Contract #: 04-0120F4Cty: SF/ALA Rte: 80 PM: 13.2/13.9File #: 99.28**WELDING INSPECTION REPORT**

Report No: WIR-030076
Date Inspected: 26-Sep-2013

Project Name: SAS Superstructure **OSM Arrival Time:** 700
Prime Contractor: American Bridge/Fluor Enterprises, a JV **OSM Departure Time:** 1530
Contractor: Steward Machine Co. **Location:** Birmingham, AL

CWI Name:	Fred Hudson (Cert. #01061501)	CWI Present:	Yes	No
Inspected CWI report:	Yes No N/A	Rod Oven in Use:	Yes	No N/A
Electrode to specification:	Yes No N/A	Weld Procedures Followed:	Yes	No N/A
Qualified Welders:	Yes No N/A	Verified Joint Fit-up:	Yes	No N/A
Approved Drawings:	Yes No N/A	Approved WPS:	Yes	No N/A
		Delayed / Cancelled:	Yes	No N/A
Bridge No:	34-0006	Component:	E2 Shear Key Anchorages

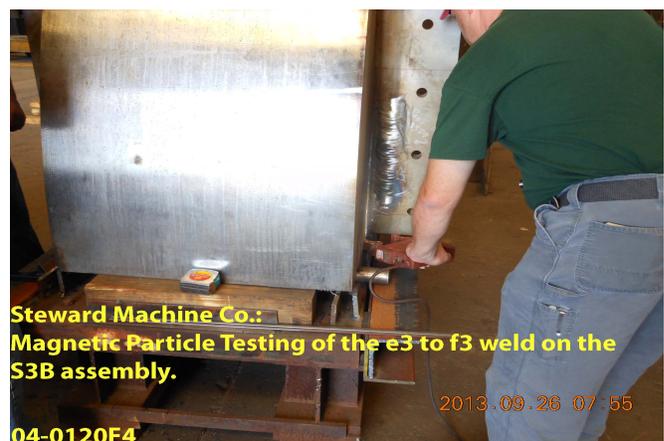
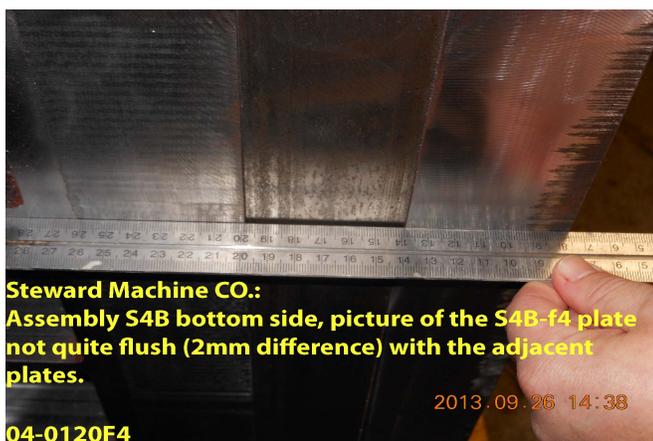
S3B Assembly Visual Testing (VT) and Magnetic Particle Testing (MPT):

- VT/MPT of e3 plate to f3 plate weld at Side A & B was acceptable.
- VT/MPT of Strap root pass on Side A acceptable.

S4B Assembly Visual Testing (VT) and Magnetic Particle Testing (MPT):

- VT/MPT of s3 round bar fillet welds on Sides A & B acceptable.
- VT/MPT of Strap welds on Sides A & B acceptable.
